WESTERN PRODUCTS
7777 N. 73rd St.
Milwaukee, Wisconsin 53223
(414) 354-2310

A-Frame Stop Modification

For Additional Blade Lift

SUPPLEMENTAL INSTRUCTION

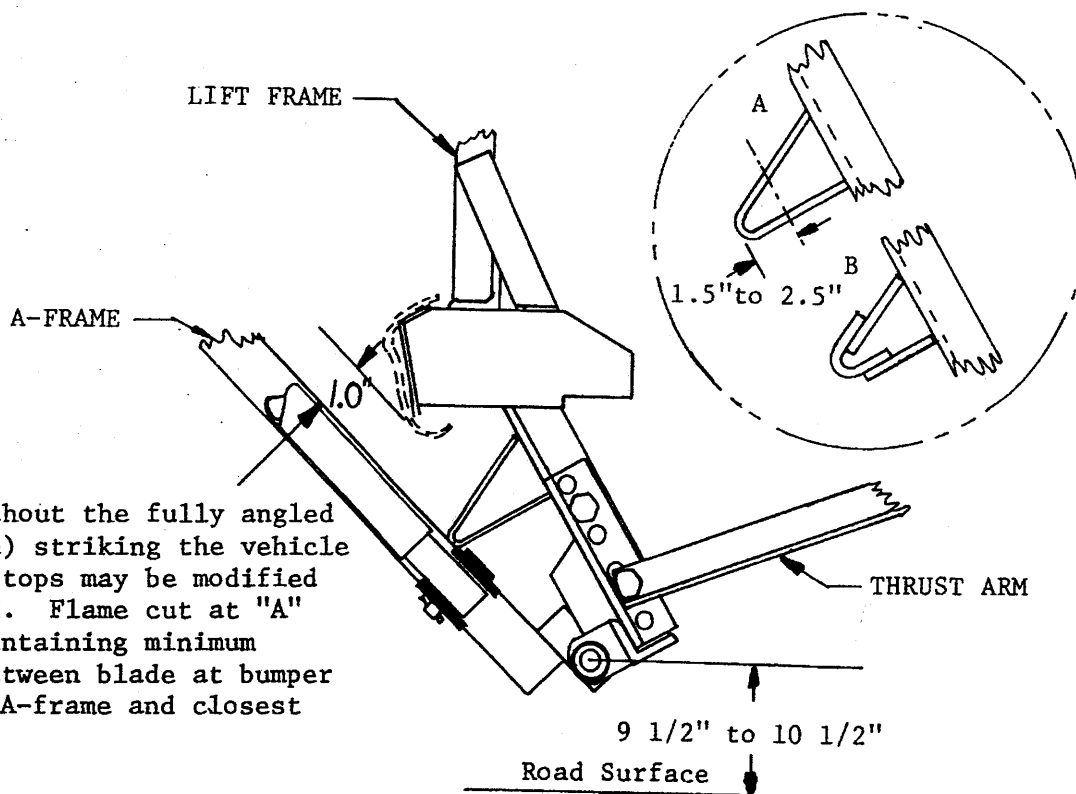
With snowplows mounted to vehicles having small tire size options, the blade lift may be less than desirable. If this condition exists on any installation, the height of blade lift can be increased by cutting and rewelding the A-frame stops on the mount as shown in the sketch below.

To gain max. lift without the fully angled blade (or the A-frame) striking the vehicle bumper, the A-frame stops may be modified as shown in the inset. Flame cut at "A" and reweld at "B" maintaining minimum 1.0 inch clearance between blade at bumper ends, and/or between A-frame and closest point of bumper.
